8. Well Name and No. Jicarilla  
Apache A118 #25

SUNDRY NOTICES AND REPORTS ON WELLS

Reference Sundry Notice Approved March 27, 1995 (P&A procedure)  
MW Petroleum proposes to change and/or amend the following procedural steps:

Revised P+A procedure All cement Class B.

Revised Proposed Wellbore Diagram

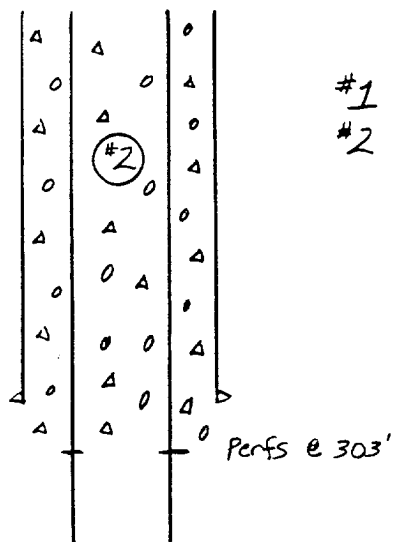
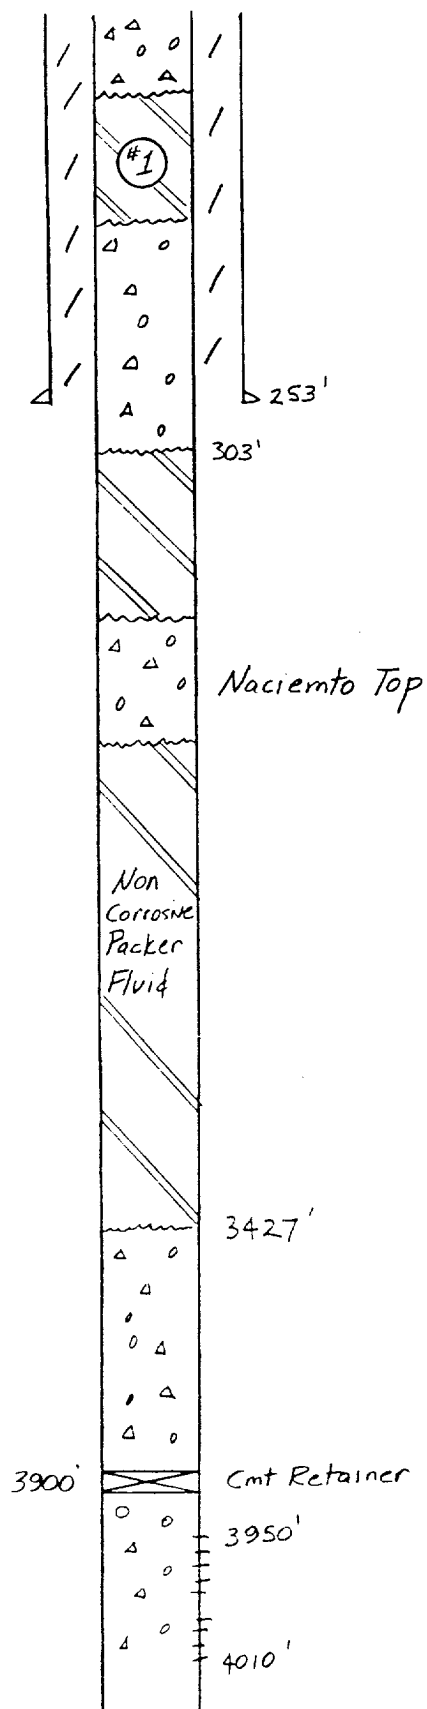
All spacer fluid - 8.33#/gal water with corrosion inhibitor.

1. MIRVUS. TOH w/ rods, pump laying down. Tag up with tbg, TOT.
2. TIT w/ tbg set cmt retainer, set @ 3900'. Sting out, circ well w/ spacer fluid. Press test csg to 500 PSI f/ 10 min.

3. Sting back into ret., cmt perms f/ 3950' to 4010' w/ 20 sx (23.6 ft<sup>3</sup>) cmt under ret. Sting out, spot 35 sx (41.3 ft<sup>3</sup>) from retainer to 3427', covering Fruitland and Ojo Alamo.

4. TOH to 50' below Nacimiento top (to be determined from open hole logs), spot 12 sx (14.2 ft<sup>3</sup>) cmt. TOT.
5. Hook up pump on braidenhead, attempt to pump into or pressure test to 500 PSI.

- a. If pressure tests - TIT w/ tbg, spot 12 sx (14.2 ft<sup>3</sup>) from 141' to 303'. Spot surface plug from 0' to 60'.
  - b. If braidenhead can be pumped into - perf csg @ 303' w/ 4 squeeze holes. Bullhead down csg, est rate, circ out braidenhead. Cmt down csg, circ cmt to surface. Leave cmt @ surface both inside and outside of 4 1/2" csg. (Minimum of 63 sx (74.3 ft<sup>3</sup>))

6. Cut off wellhead, fill voids in csg w/ cmt. Install P+A marker.
7. Remediate location to BLM specs.

Proposed Plugging Wellbore

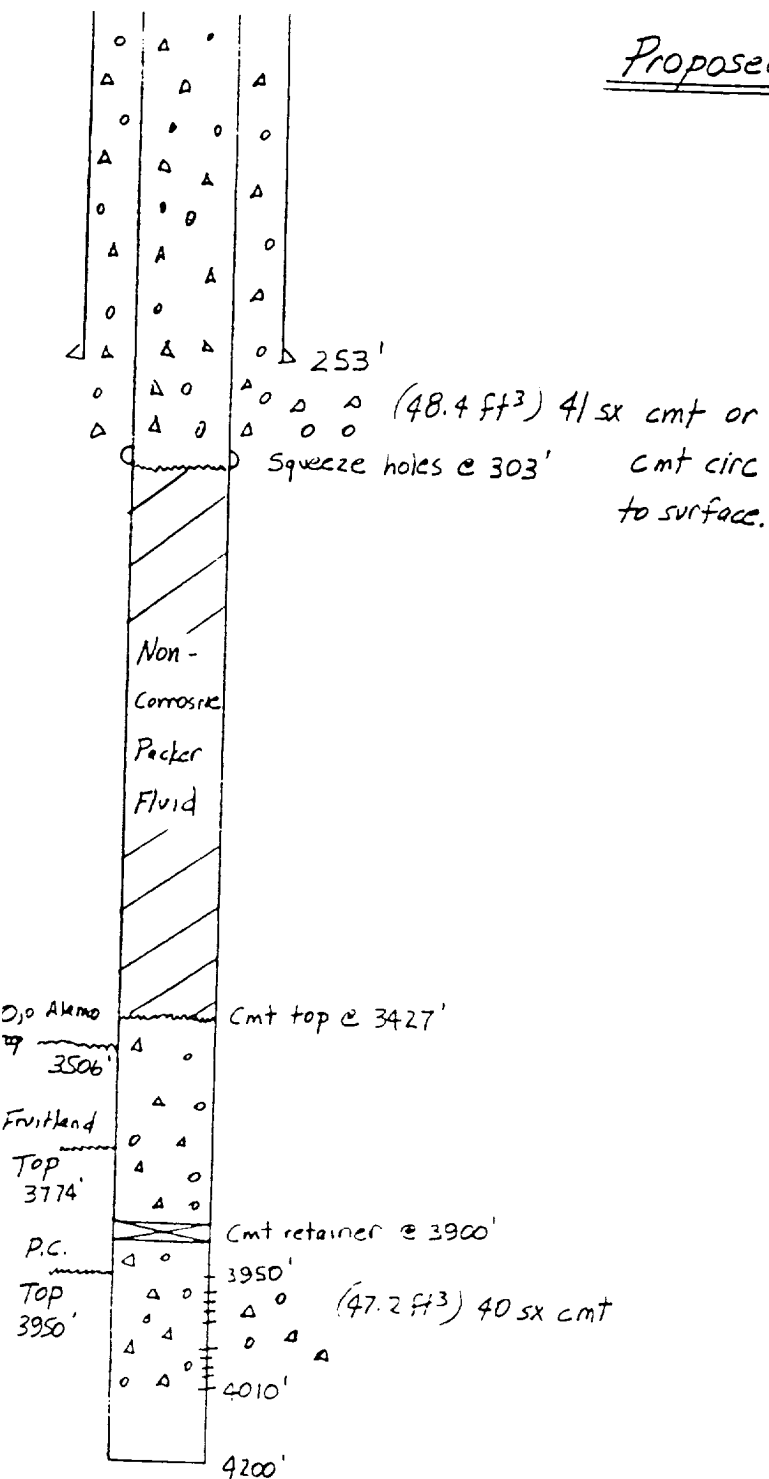
Proposed Plugging Procedure - all cmt Class B neat.

1. MIRUSU. TOH w/ rods, pump laying down. Release tbg anchor, T1H, tag up. TOH.
2. T1H w/ tbg set cmt retainer, set @ 3900'. Sting out, circ hole w/ 9.0 #/gal packer fluid. Press test csg to 500 PSI f/ 10 min.

3. Sting back into retainer, cmt perfs f/ 3950' to 4010' w/  $(47.2 \text{ ft}^3)$  40sx cmt behind csg, leave  $(9.6 \text{ ft}^3)$  8.1 sx cmt in csg f/ cmt retainer @ 3900' to btm perf @ 4010'. Sting out of ret., spot  $(41.3 \text{ ft}^3)$  35sx cmt f/ ret @ 3900', leaving cmt top @ 3427'. TOH w/ tbg.

4. Load csg w/ pkr fluid. Perf  $4\frac{1}{2}"$  csg @ 303' (surface shoe @ 253') w/ 2 squeeze holes.
5. Pump down csg, attempt to establish circ thru surface pipe.

6. If circ is established:
  - a. T1H w/ 1 jt tbg, 1 tbg sub. Pump down tbg w/ neat cmt thru squeeze holes @ 303' and circ cmt thru braidenhead.
  - b. Pull tbg. Remove BOP, cut off wellhead, exposing both  $4\frac{1}{2}"$  csg and  $8\frac{7}{8}"$  csg.

- c. Using tbg or 1" pipe, T1H to cmt, finish filling voids w/ cmt to surface.
  - d. Est min cmt to pump @  $(97.9 \text{ ft}^3)$  83 sx cmt to fill  $4\frac{1}{2}"$  csg and between  $4\frac{1}{2}"$  and  $8\frac{7}{8}"$  csg strings.

- e. Install P+A marker.
7. If circ is not established. (Fluid is being pumped into formation)
  - a. T1H w/ 1 jt tbg, 1 tbg sub. Pump down tbg w/ neat cmt thru squeeze holes, putting  $(48.4 \text{ ft}^3)$  41 sx cmt behind  $4\frac{1}{2}"$  csg, leaving  $(25.4 \text{ ft}^3)$  21.5 sx inside  $4\frac{1}{2}"$  csg.

- b. Same as b, c, e above.
8. Remediate reserve pit, location. Reseed location to BLM specs.
